UNITED STATES PATENT AND TRADEMARK OFFICE

APPLICATION NO.	FILING DATE	FIRST NAMED INVENTOR	ATTORNEY DOCKET NO.	CONFIRMATION NO.
10/672,599	09/26/2003	Kenneth Reeve	BSC-157DV	1962
30636	7590	04/05/2005	EXAMINER	
FAY KAPLUN & MARCIN, LLP 150 BROADWAY, SUITE 702 NEW YORK, NY 10038			BOGART, MICHAEL G	
			ART UNIT	PAPER NUMBER
			3761

Office Action Summary

DETAILED ACTION

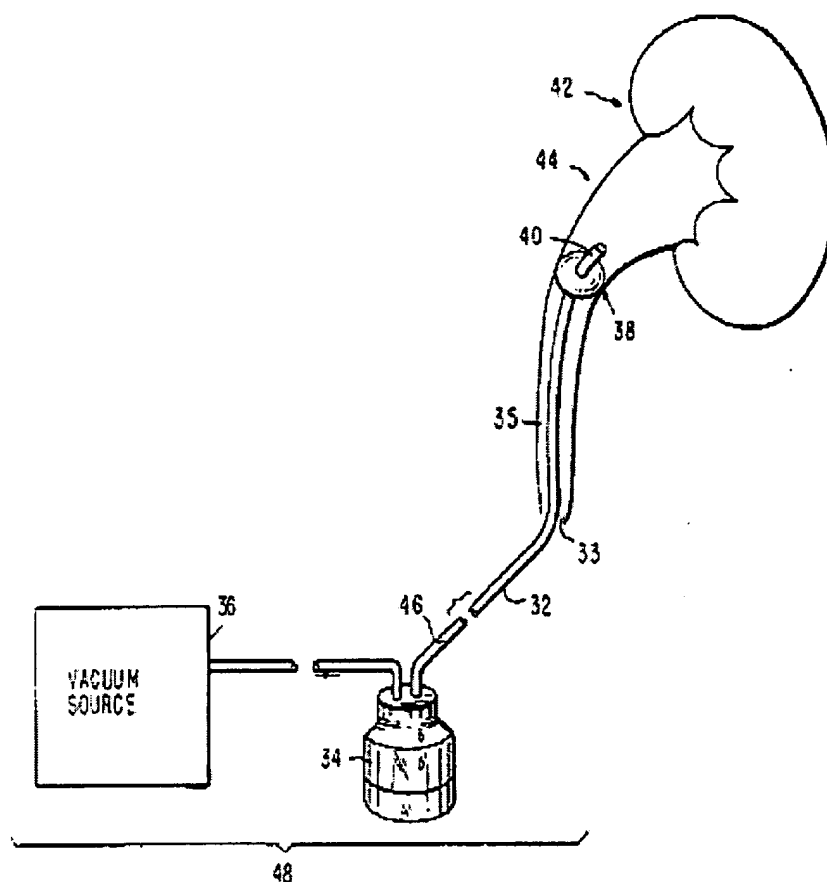
Ikeguchi teaches a first catheter (32) positionable in a patient's first ureter (35), the first catheter (32) having a proximal and a distal end (40, 46), the proximal end (40) of the catheter (32) including a ureter to catheter seal (38), the distal end (46) of the catheter capable of passing through the patient's urinary sphincter, the distal end (46) of the catheter capable of being connected to an external urine collector (34)(see fig. 2, below).

Ikeguchi expressly discloses the claimed invention except for there being two catheters, one for each ureter of a patient.

In the present case, it would have been obvious to one of ordinary skill in the art to modify the system of Ikeguchi to include two catheters in order to provide for patients who need simultaneous treatment of both ureters.
